# Electrical
# Miscellaneous Schedules

RIVERSIDE ROAD PUMP STATION
UPGRADES
575 RIVERSIDE ROAD, ROSWELL GA. 30075

ADDENDUM NO.
4

# Instrumentation Main Sewage Pump P&ID

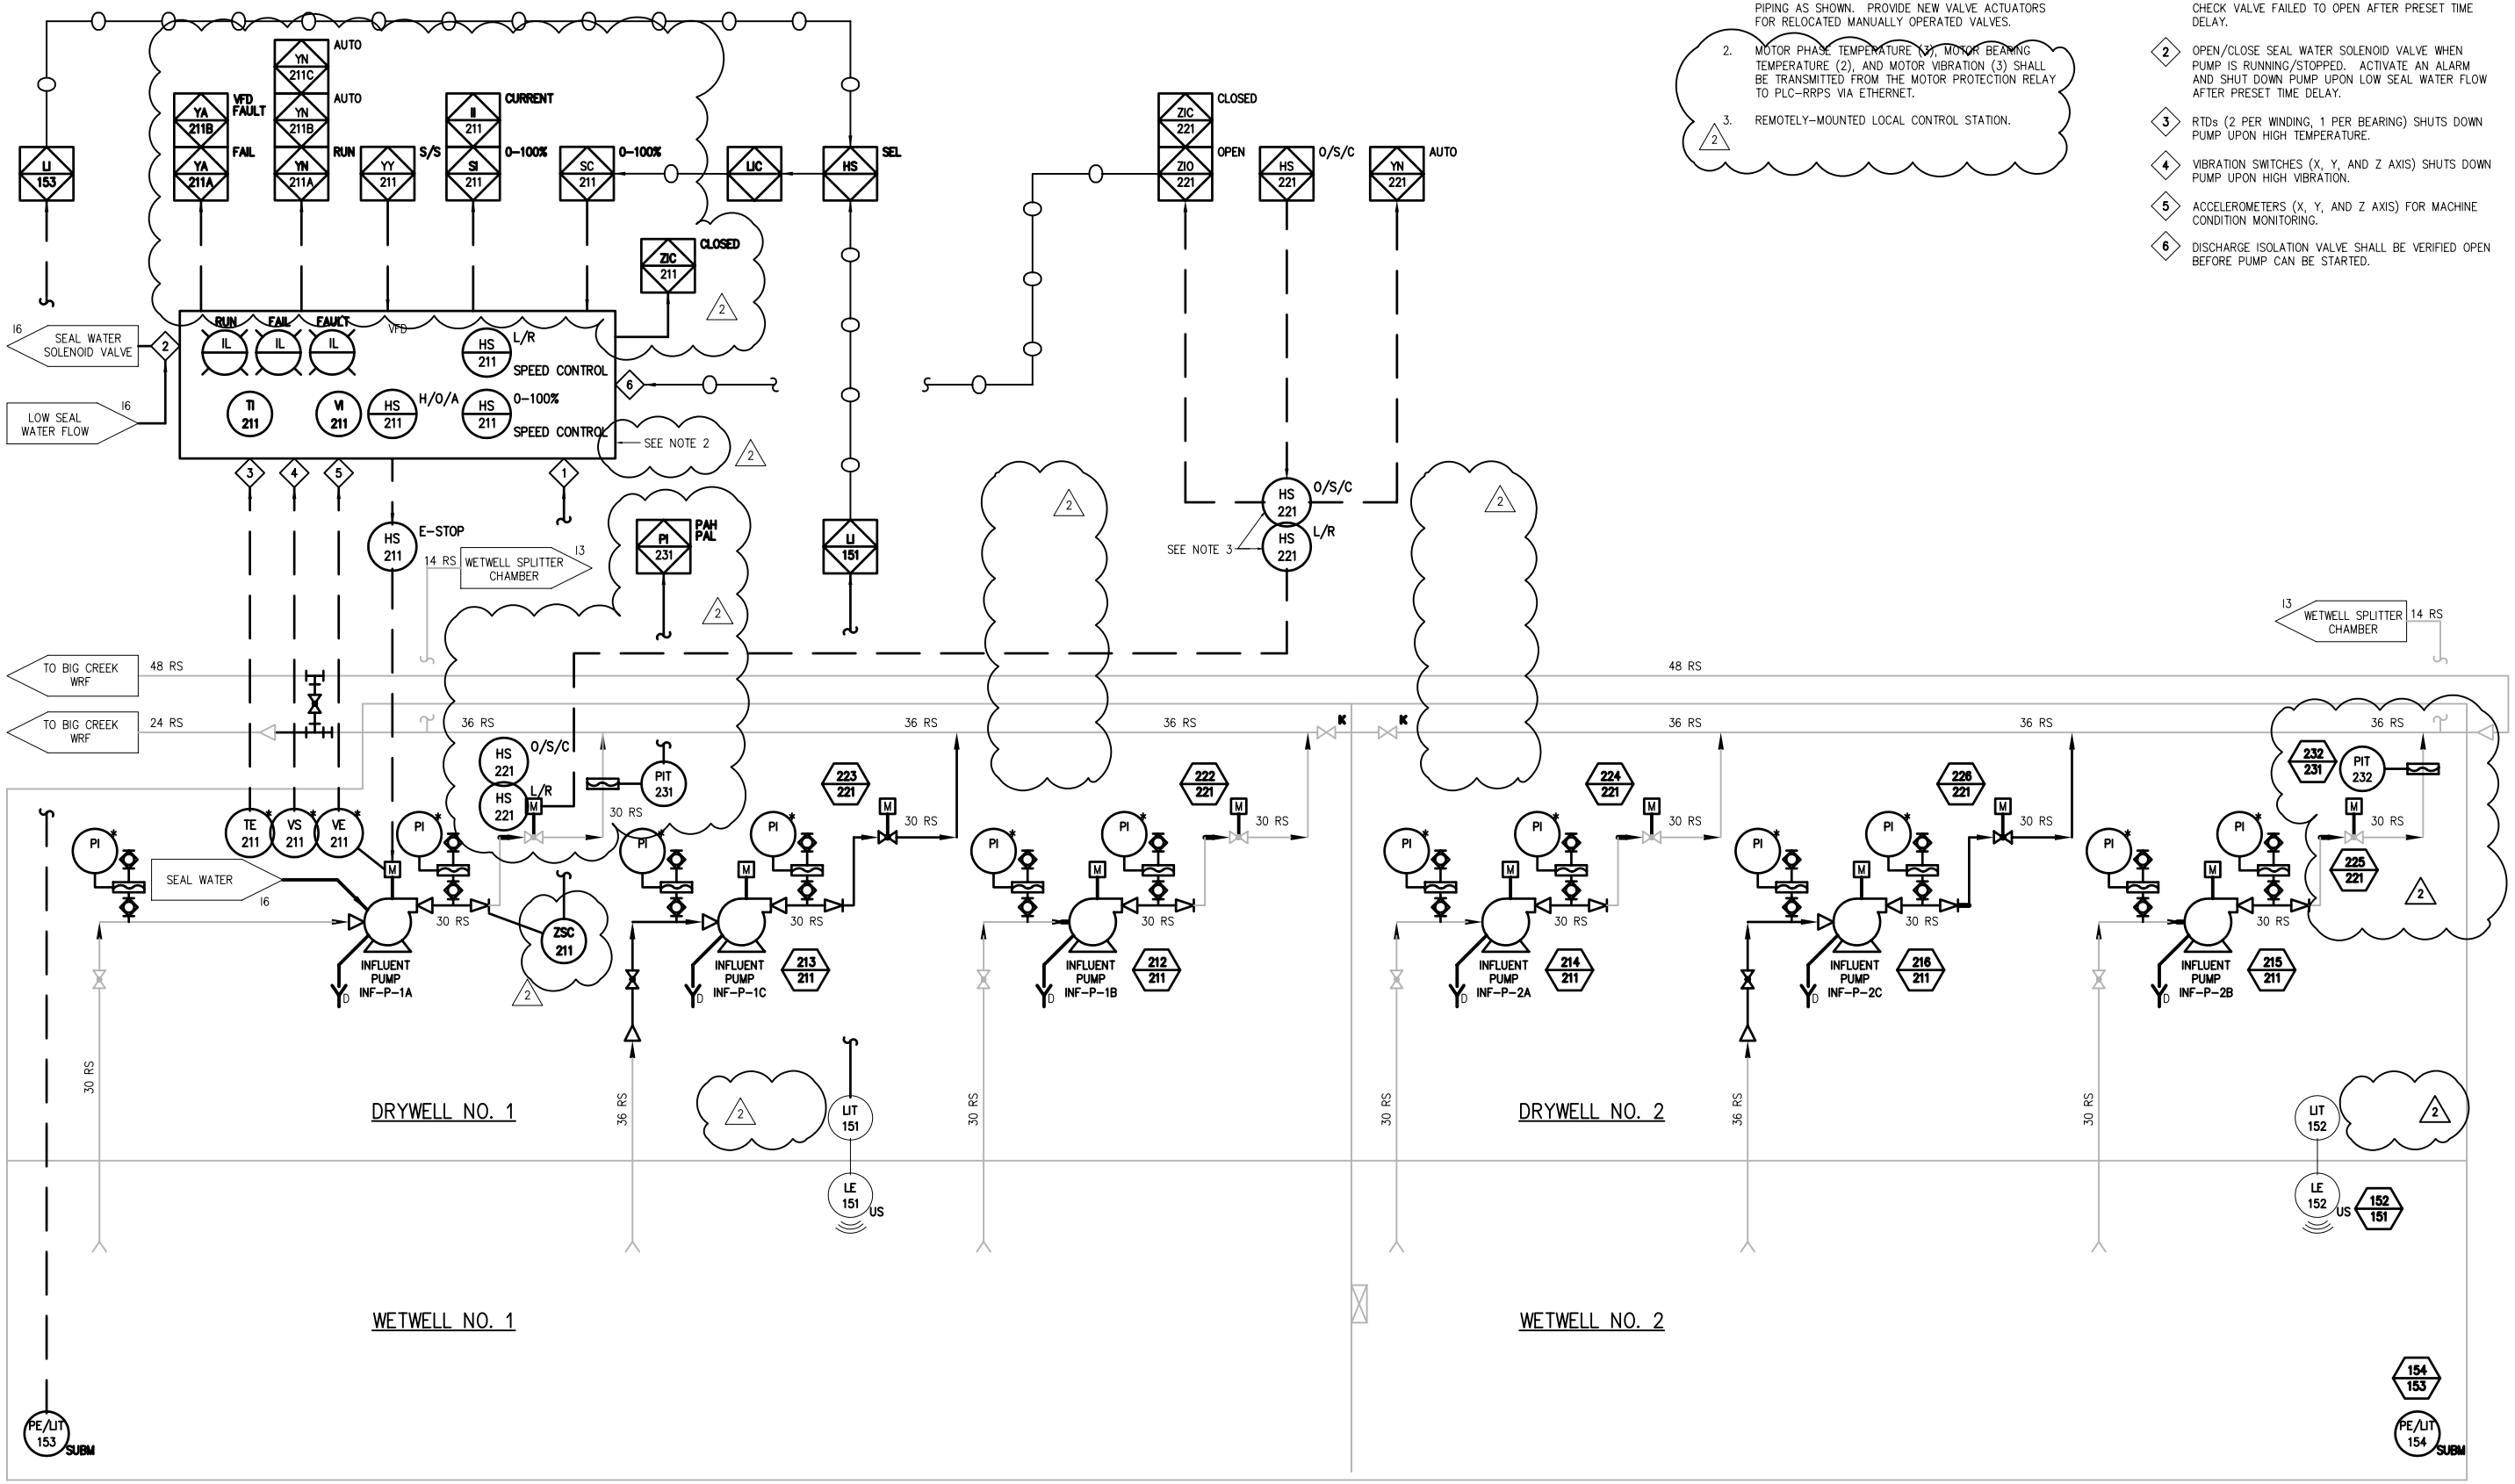
1. EXISTING PLUG VALVE FOR PUMPS INF-P-1A, INF-P-1B, INF-P-2A, AND INF-P-2B SHALL BE RE-USED AS ISOLATION VALVES IN PUMP DISCHARGE PIPING AS SHOWN. PROVIDE NEW VALVE ACTUATORS FOR RELOCATED MANUALLY OPERATED VALVES.
2. MOTOR PHASE TEMPERATURE (3), MOTOR BEARING TEMPERATURE (2), AND MOTOR VIBRATION (3) SHALL BE TRANSMITTED FROM THE MOTOR PROTECTION RELAY TO PLC-RRPS VIA ETHERNET.
3. REMOTELY-MOUNTED LOCAL CONTROL STATION.

1. CHECK VALVE SHALL BE CLOSED FOR PUMP START PERMISSIVE. CHECK VALVE SHALL BE VERIFIED OPEN AFTER PRESET TIME DELAY AFTER PUMP STARTS. ACTUATE AN ALARM AND SHUT DOWN PUMP UPON CHECK VALVE FAILED TO OPEN AFTER PRESET TIME DELAY.
2. OPEN/CLOSE SEAL WATER SOLENOID VALVE WHEN PUMP IS RUNNING/STOPPED. ACTIVATE AN ALARM AND SHUT DOWN PUMP UPON LOW SEAL WATER FLOW AFTER PRESET TIME DELAY.
3. RTDs (2 PER WINDING, 1 PER BEARING) SHUTS DOWN PUMP UPON HIGH TEMPERATURE.
4. VIBRATION SWITCHES (X, Y, AND Z AXIS) SHUTS DOWN PUMP UPON HIGH VIBRATION.
5. ACCELEROMETERS (X, Y, AND Z AXIS) FOR MACHINE CONDITION MONITORING.
6. DISCHARGE ISOLATION VALVE SHALL BE VERIFIED OPEN BEFORE PUMP CAN BE STARTED.

| ADDENDUM NO. | DATE | Instrumentation Odor Control System P&ID | H & S JOB NUMBER | REFER TO CONTRACT DRAWING NUMBER |

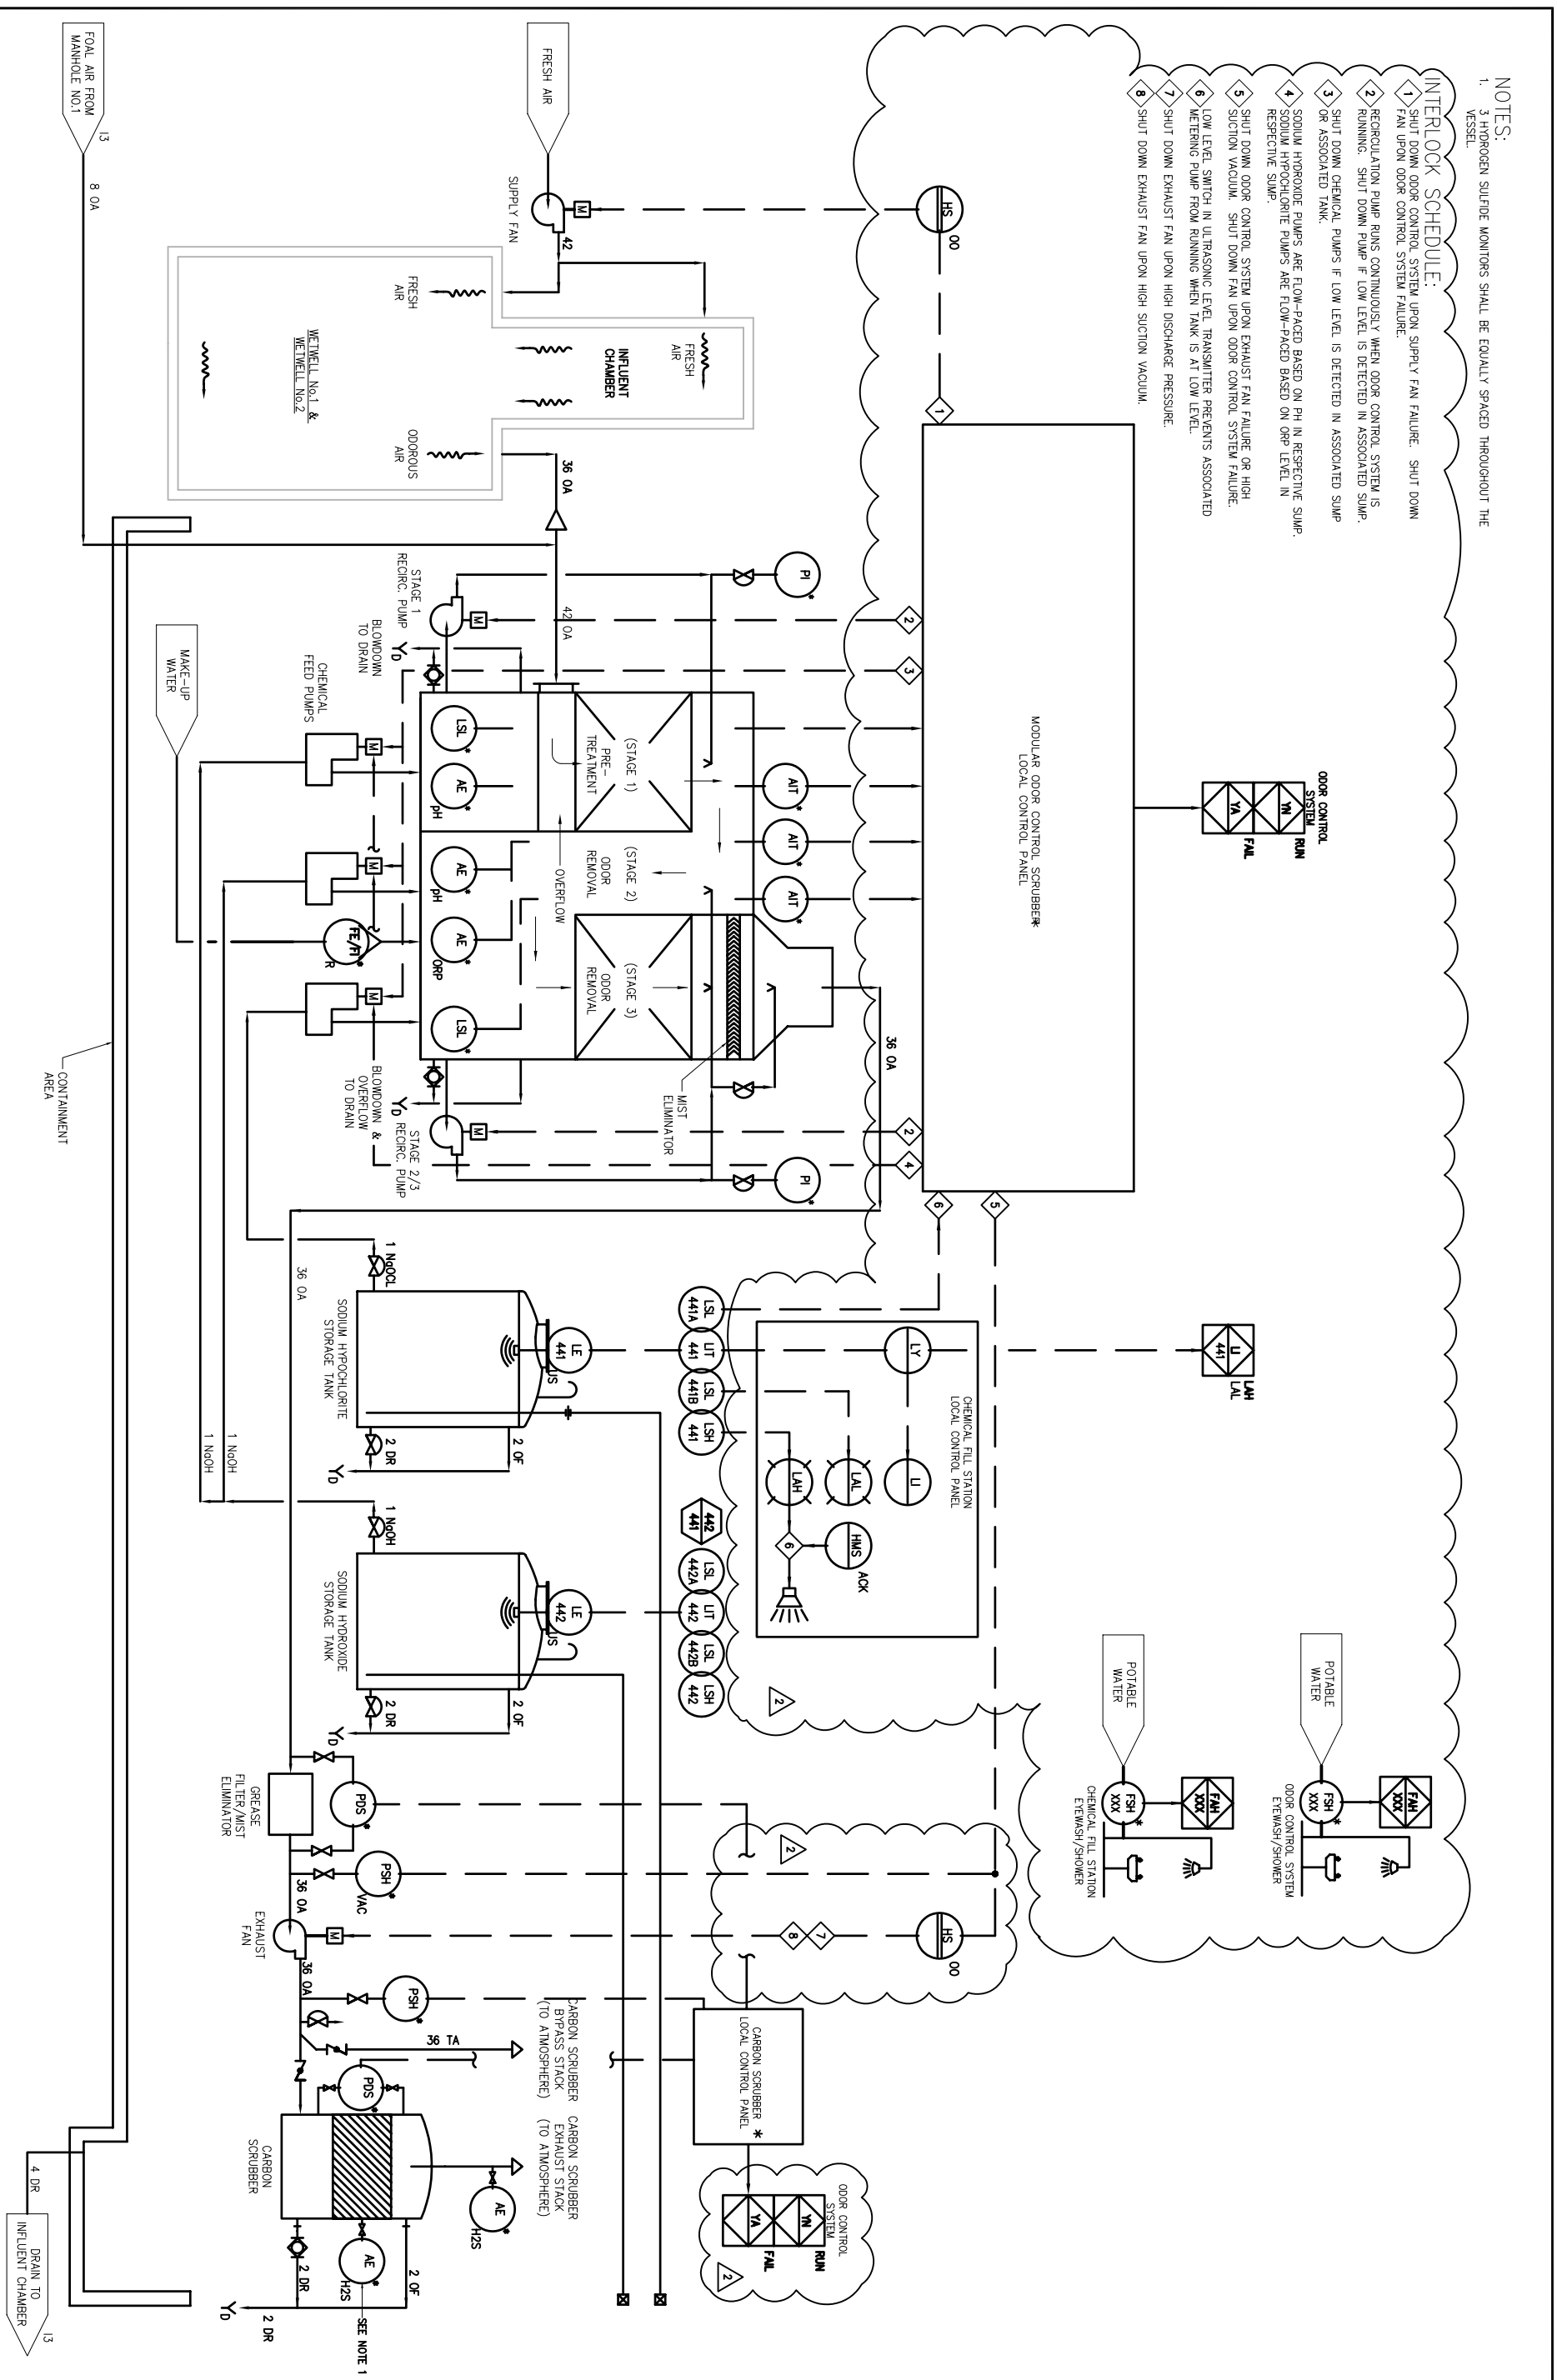
1. 3 HYDROGEN SULFIDE MONITORS SHALL BE EQUALLY SPACED THROUGHOUT THE VESSEL.

1. SHUT DOWN ODOR CONTROL SYSTEM UPON SUPPLY FAN FAILURE. SHUT DOWN FAN UPON ODOR CONTROL SYSTEM FAILURE.
2. RECIRCULATION PUMP RUNS CONTINUOUSLY WHEN ODOR CONTROL SYSTEM IS RUNNING. SHUT DOWN PUMP IF LOW LEVEL IS DETECTED IN ASSOCIATED SUMP.
3. SHUT DOWN CHEMICAL PUMPS IF LOW LEVEL IS DETECTED IN ASSOCIATED SUMP OR ASSOCIATED TANK.
4. SODIUM HYDROXIDE PUMPS ARE FLOW-PACED BASED ON PH IN RESPECTIVE SUMP. SODIUM HYPOCHLORITE PUMPS ARE FLOW-PACED BASED ON ORP LEVEL IN RESPECTIVE SUMP.
5. SHUT DOWN ODOR CONTROL SYSTEM UPON EXHAUST FAN FAILURE OR HIGH SUCTION VACUUM. SHUT DOWN FAN UPON ODOR CONTROL SYSTEM FAILURE.
6. LOW LEVEL SWITCH IN ULTRASONIC LEVEL TRANSMITTER PREVENTS ASSOCIATED METERING PUMP FROM RUNNING WHEN TANK IS AT LOW LEVEL.
7. SHUT DOWN EXHAUST FAN UPON HIGH DISCHARGE PRESSURE.
8. SHUT DOWN EXHAUST FAN UPON HIGH SUCTION VACUUM.
